Recommendation and decision on notification of resource consent application(s) under sections 95-95G of the Resource Management Act 1991 (RMA)

Applicant:	Woldwide One Limited and Woldwide Two Limited	
Consents sought:	Land Use Consent – to use land for the maintenance	
	and use of an existing agricultural effluent storage	
	facility	
Application reference:	APP-20191432	
Site address or location:	1915 Winton Wreys Bush Road, Otautau	
New consent(s) for new activity(ies) (s88)	$\boxtimes$	
New consent(s) for existing activity(ies) (s88)		
Change to conditions of existing consent(s) (s127)		
Activity status	Discretionary

Figure 1: Photo appended from the visual assessment taken during the assessment

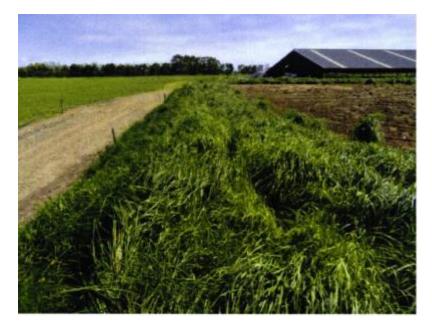
At the time of the visual assessment the effluent slurry levels in the pond were above the freeboard levels and the embankments had heavy grass growth as seen in Figure 1. I consider the visual assessment to be entirely inadequate and as such all findings have been disregarded. It is not possible for the features of the pond to have been visualised during the assessment to allow for a determination to be made regarding the suitability of the structure.
